DEPARTMENT OF TRANSPORTATION
STATE OF GEORGIA

SUBJECT **APPROVED CONCEPT REPORT**

DEPARTMENT OF TRANSPORTATION
STATE OF GEORGIA
PROJECT CONCEPT REPORT

Bridge replacement on SR 49/Old Garrison Rd @ Norfolk Southern RR 8.5 MI S of Gray, GA

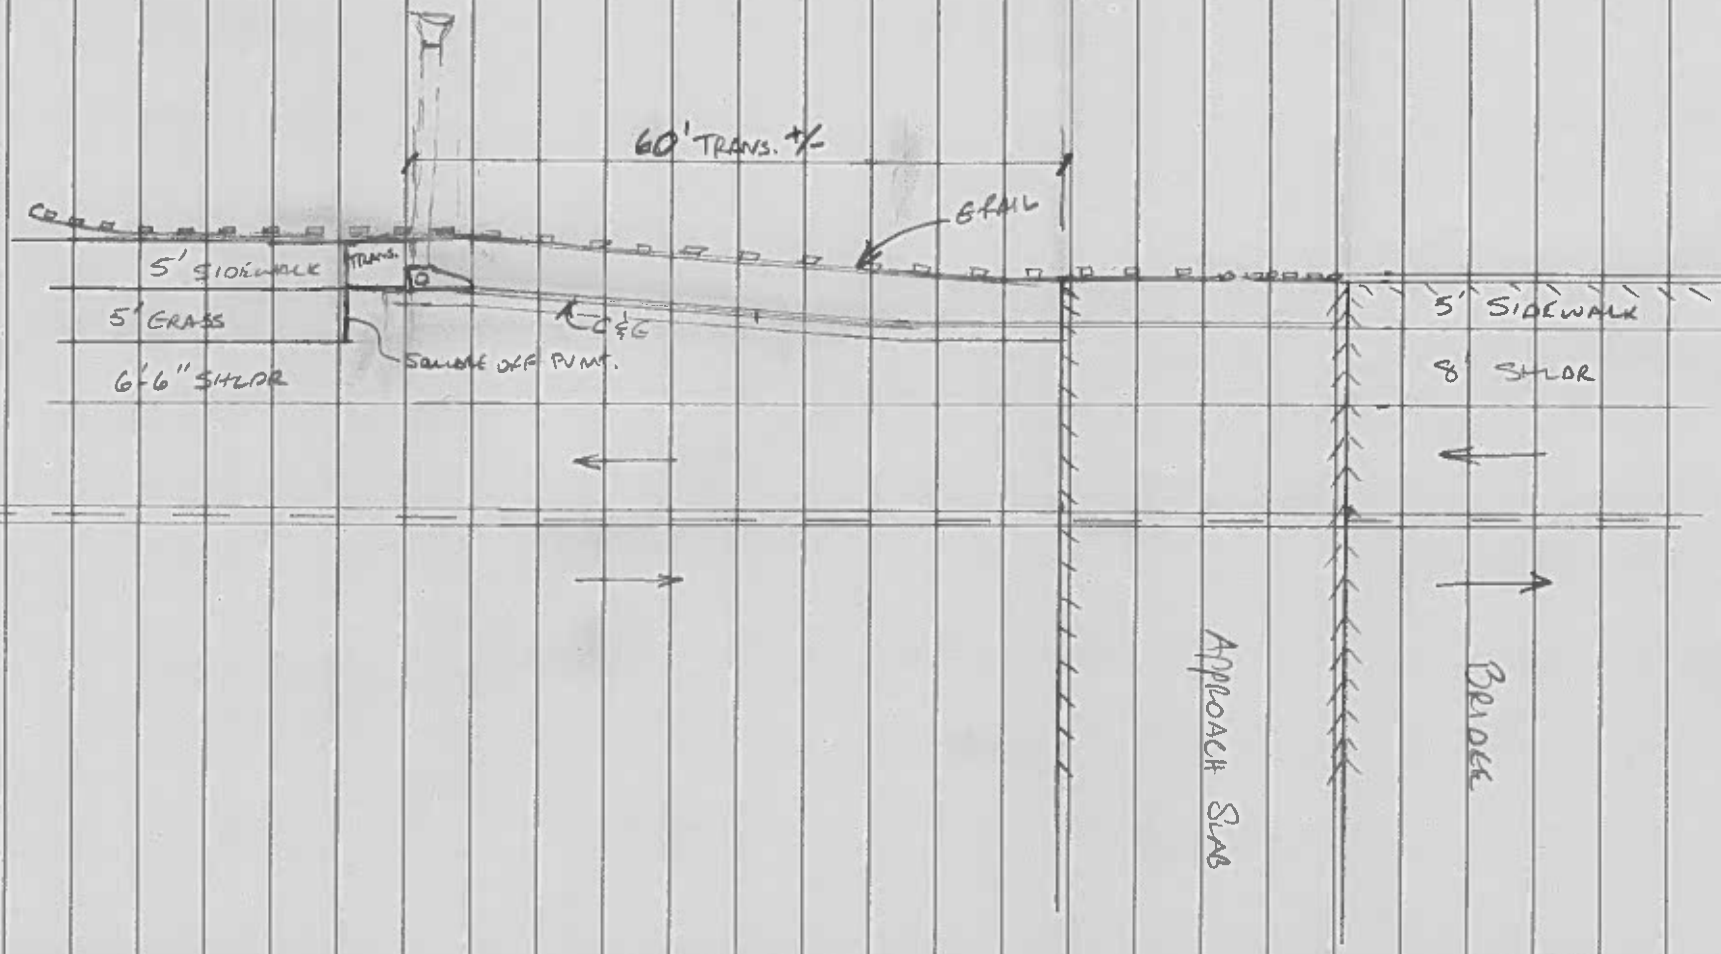
His main concern was the detail of the transition area and so I've attached a sketch of what I heard him say would be fine. Mainly it's carrying curb and gutter to beyond the width transition area.

My question now is where the sidewalk has to be raised across the bridge. Curb and gutter must be

used on either end of bridge somehow. Maybe just add striped delineation and tp 10 RPM's to separate shoulder and side walk location.

60' TRANS. +/-
RAIL
5' SIDEWALK
TRANS.
5' GRASS
6'-6" SHLDR
C&G
SALVAGE OFF PUMP.
5' SIDEWALK
8' SHLDR
APPROACH SLAB
BRIDGE
